UNITED STATES PATENT AND TRADEMARK OFFICE

APPLICATION NO.	FILING DATE	FIRST NAMED INVENTOR	ATTORNEY DOCKET NO.	CONFIRMATION NO.
10/645,667	08/22/2003	Takashi Koba	2018-768	8419
23117	7590	12/29/2005	EXAMINER	
NIXON & VANDERHYE, PC 901 NORTH GLEBE ROAD, 11TH FLOOR ARLINGTON, VA 22203			DWIVEDI, VIKANSHA S	
			ART UNIT	PAPER NUMBER
			3746

Office Action Summary

Above Figure is Figure 3 of Mukaidani. The portion between A and B is a groove as disclosed in Claim 1.

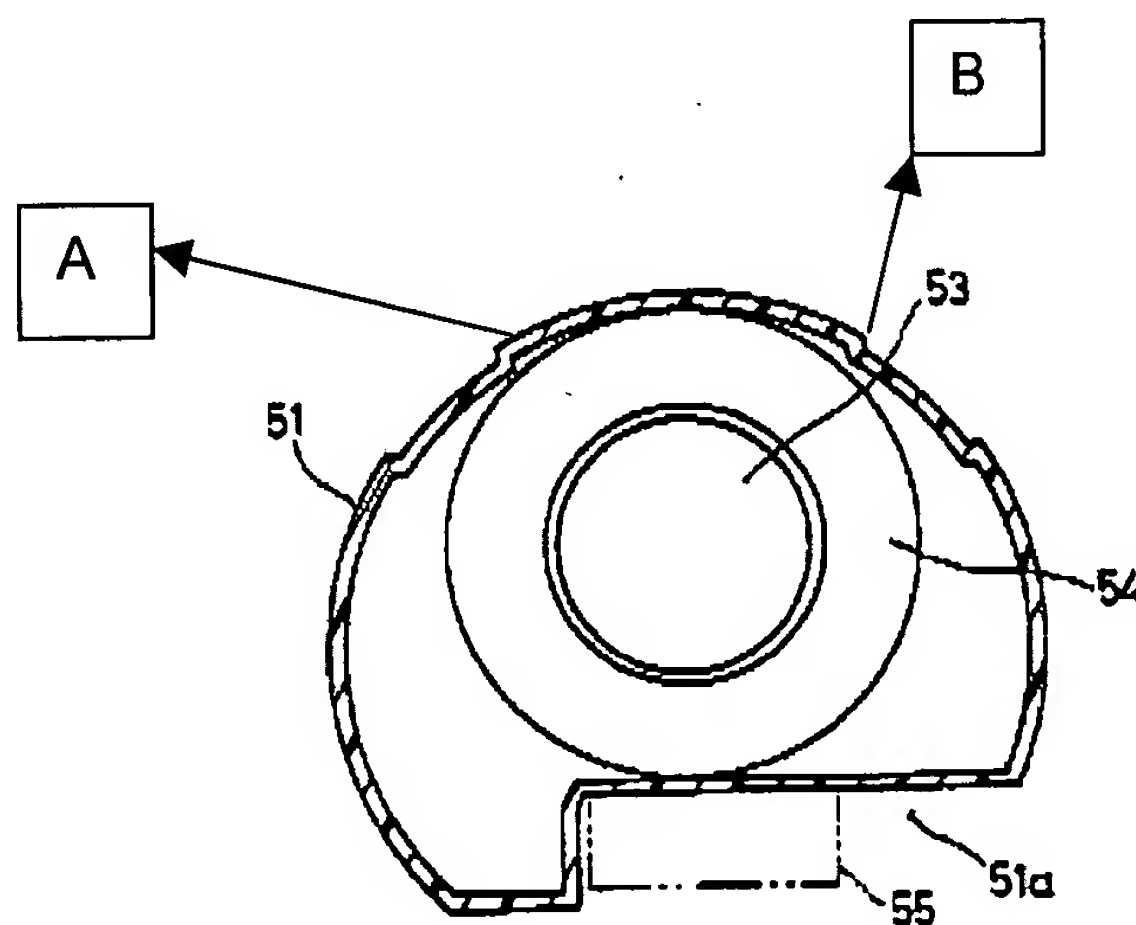
Mukaidani teaches a fuel tank (1, Figure 2 also described on Page 2) with a fuel pump (21, Figure 1). Mukaidani refers to his pump as "fuel pump" not "electrical fuel pump", though it is clear from the description and the Figure 2 which shows an electrical connector (14, Figure 2) that it is indeed an electrical fuel pump. It also discloses a connecting member as shown in figure 2 (42) and described on page 3, line 47 of the text, which Mukaidani refers to as connecting pipe.
